Addendum No. 3
August 22, 2023

Theron W. Ward Judicial Building Remodel and Expansion

ADDENDUM

Addendum No.	03	Owner Project Number	21403.000	Date Issued	August 21, 2023
---------------------	----	-----------------------------	-----------	--------------------	-----------------

1 UTILITY PLAN
SCALE: 1" = 20'
0 10 20 40 60 80
SCALE IN FEET

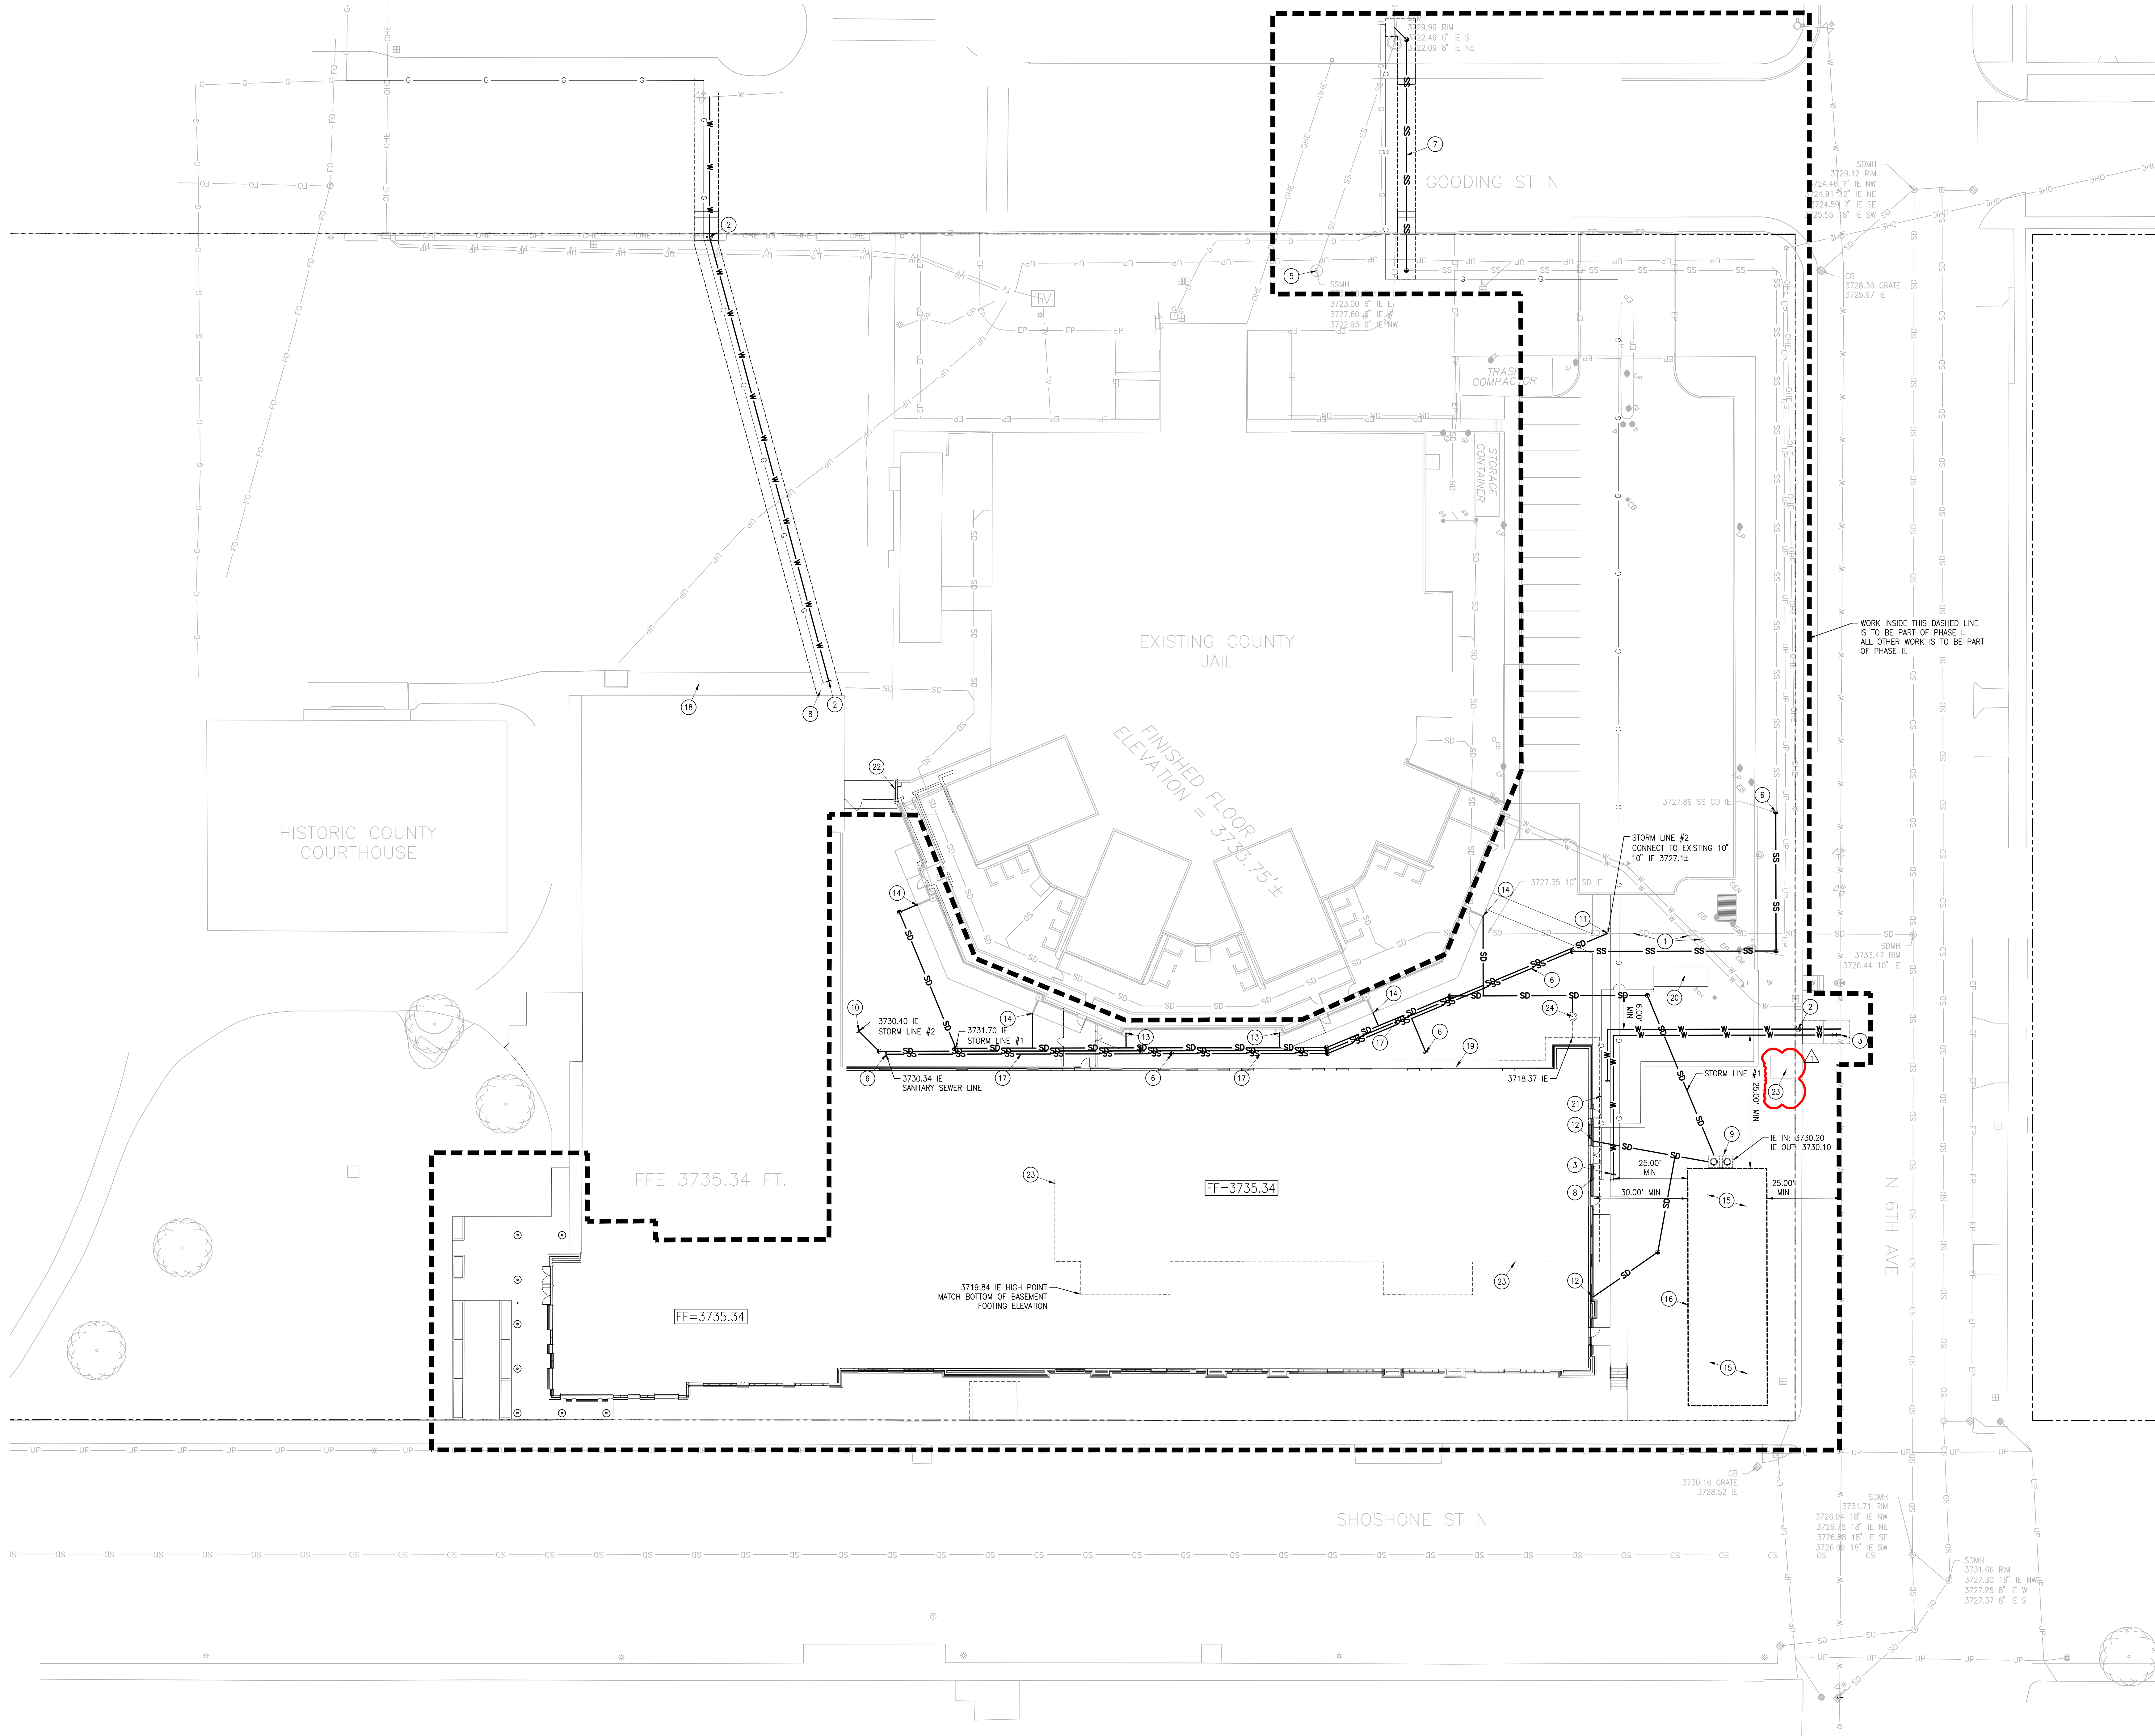
3. **Question:** Can you define further the bollard noted on Sheet C40, sheet note 5.

Response: Supplement Door Hardware Group A101A found in Specification Section 087100 with an Allegion Wireless Full-Length Actuator and Bollard Package.

SHEET
151

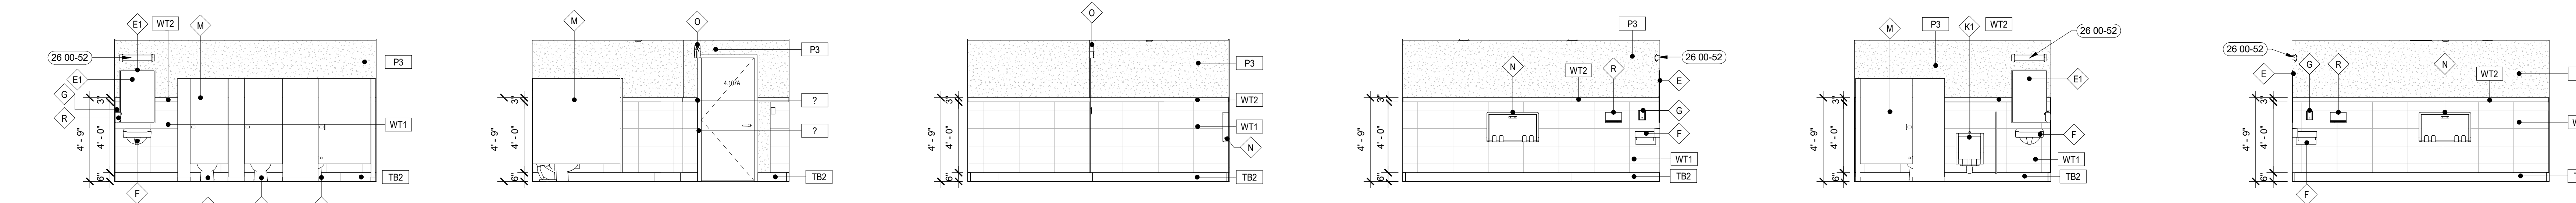
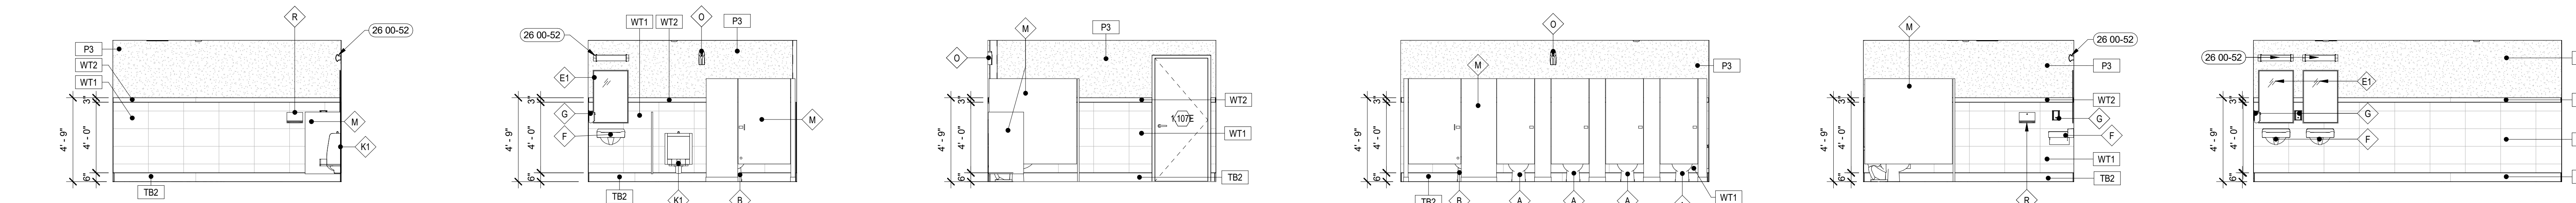
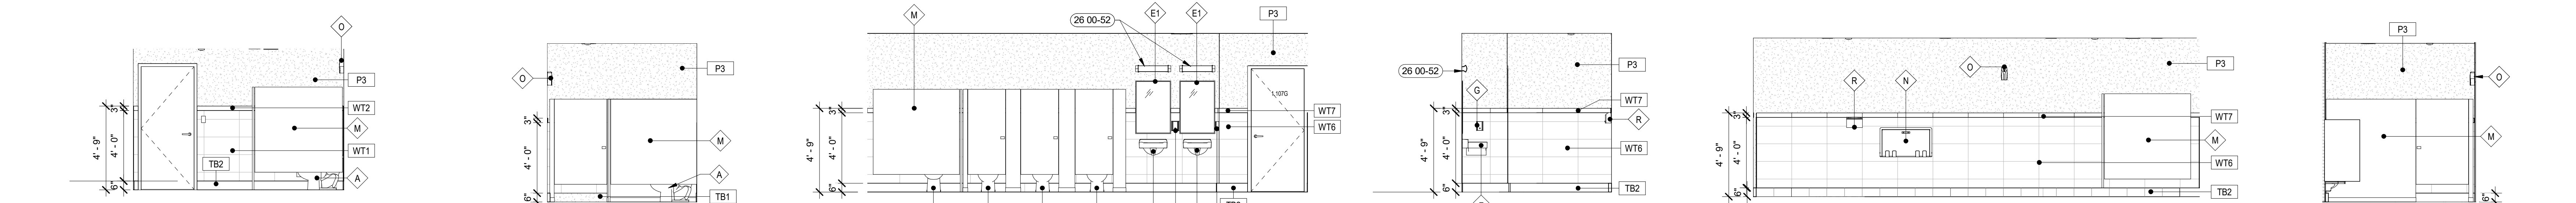
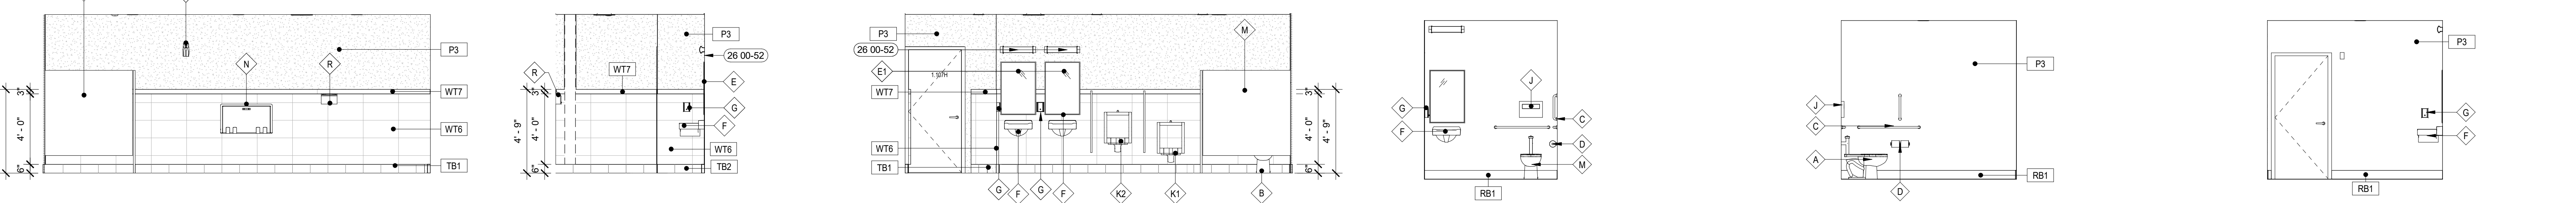
7. **Question:** Where can the interior elevations for Toilet Room 1.107G and 1.107H be found?

Response: Utilize detail I51-22 for the East wall of room 1.107G. Utilize I51-23 for the South wall of room 1.107G. Utilized I51-24 for the West wall of room 1.107G. Utilize I51-25 for with North wall of room 1.107H. Utilize I51-26 for the East wall of room 1.107H. Utilize I51-27 for the South wall of room 1.107H.
